# UNITED STATES PATENT AND TRADEMARK OFFICE

APPLICATION NO.	FILING DATE	FIRST NAMED INVENTOR	ATTORNEY DOCKET NO.	CONFIRMATION NO.
10/090,221	03/04/2002	James L. Dunn	P6228	3497

## Office Action Summary

## DETAILED ACTION

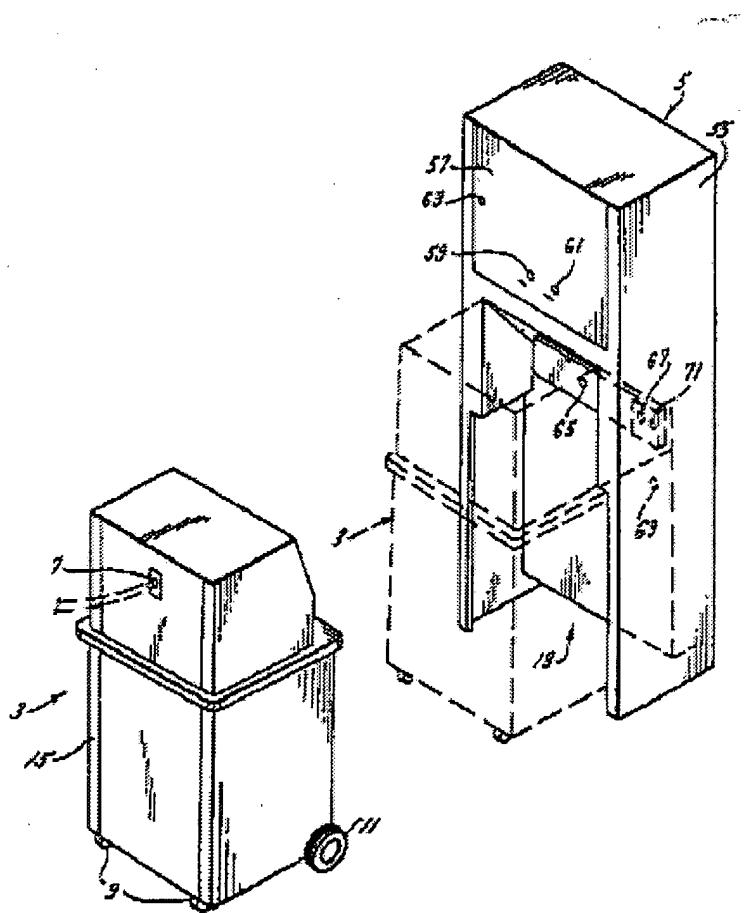
Claims 1, 2 and 9 are rejected under 35 U.S.C. § 102(b) as being anticipated by Parker (US 4,863,446).

Parker teaches a cart (3) for collecting medical waste comprising a body (15) supported by a plurality of wheels (11);

a container (81) supported by said body (15) and having a drain port (53) therein;

a cap positioned on said container (81) and including a patient port (31) and a vacuum port (7) said patient port (31) adapted to selectively communicate with a suction line (33) and said vacuum port (7) adapted to selectively communicate with a vacuum source (fig. 9); and

a liquid level detector (21) in communication with said container (81);

whereby medical waste is collected in said container (81) through a suction line (33) connected to said patient port (31) when said vacuum port (7) is connected to a vacuum source (fig. 9) and the collected medical waste in the container (81) may be detected via the liquid level detector (21)(see fig. 1, below).

Regarding the container cap, the container (81) taught by Parker is designed to operate under a vacuum and inherently has some sort of cap to provide the sealed enclosure necessary to provide such a vacuum.
